Well Name: GUSS FED COM 0731	Well Location: T26S / R36E / SEC 7 / SWSE / 32.0517189 / -103.3007343	County or Parish/State: LEA / NM
Well Number: 213H	Type of Well: OIL WELL	Allottee or Tribe Name:
Lease Number: NMNM140366	Unit or CA Name:	Unit or CA Number:
US Well Number: 3002555291	Operator: MATADOR PRODUCTION COMPANY

Notice of Intent

Sundry ID: 2887993

Procedure Description: BLM Bond# NMB001079; Surety Bond# RLB0015172 Matador requests to skid over to spud the well using a new surface hole location, as reflected in this sundry, due to surface casing collapse at the original location. As reflected in the attached, the completed lateral and bottom hole location for the well remains the same. We understand the NMOCD will then assign the replacement well under this sundry a new API number, leaving the original location with its same API number. The original well will be named GUSS FED COM 0731 213Y (API 30-025-55291). The well we will skid to spud will be named GUSS FED COM 0731 213H and will be assigned a new API # from NMOCD. Please see the attached supporting documents. P&A sundry has already been submitted (Sundry ID 2887407).

SECTION 7, TOWNSHIP 26-S, RANGE 36-E, N.M.P.M.
LEA COUNTY, NEW MEXICO

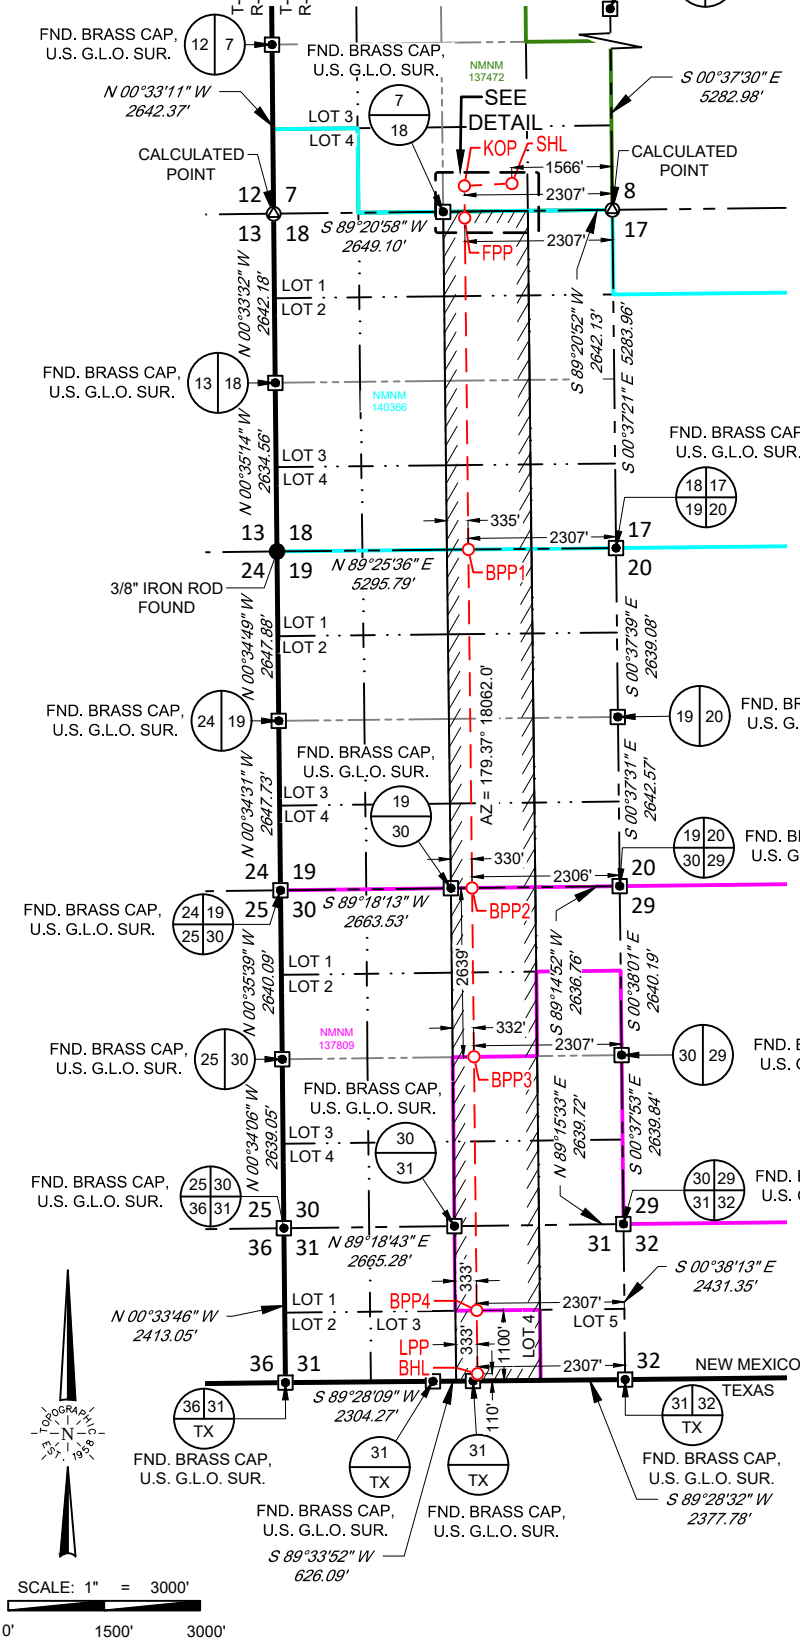
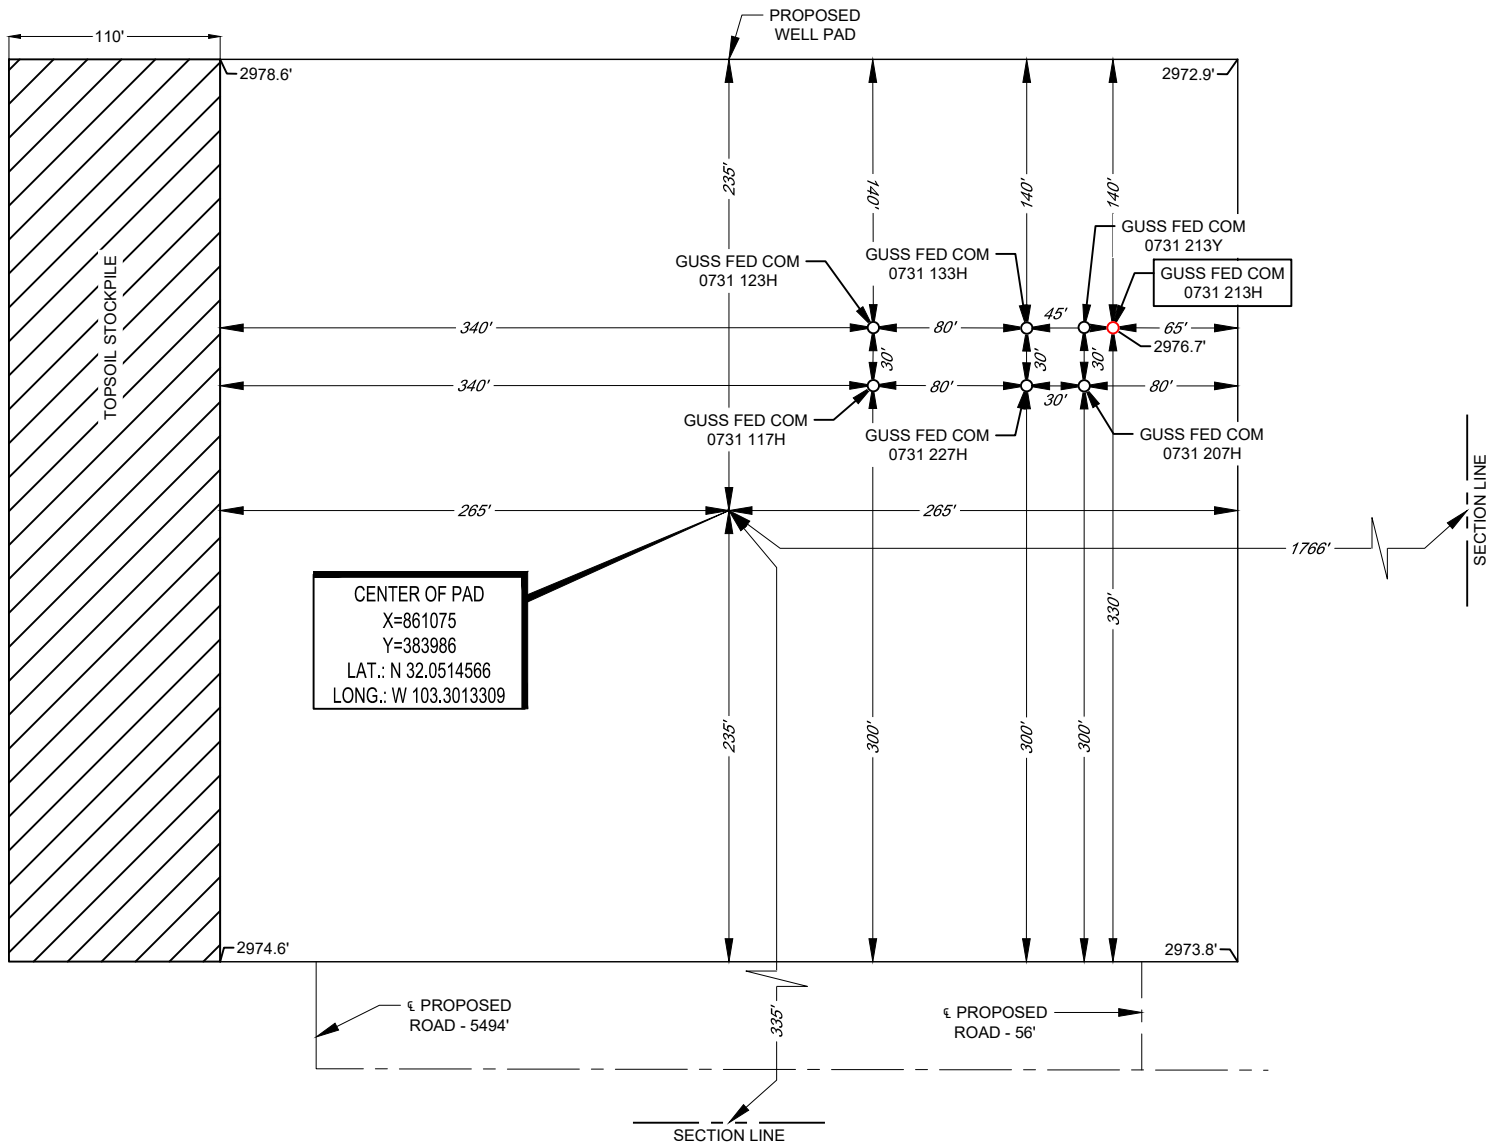
- Matador requests to change the surface hole location from 1581' FEL to 1566' FEL as per the attached C-102. Directional plans and drilling plan has been updated accordingly.
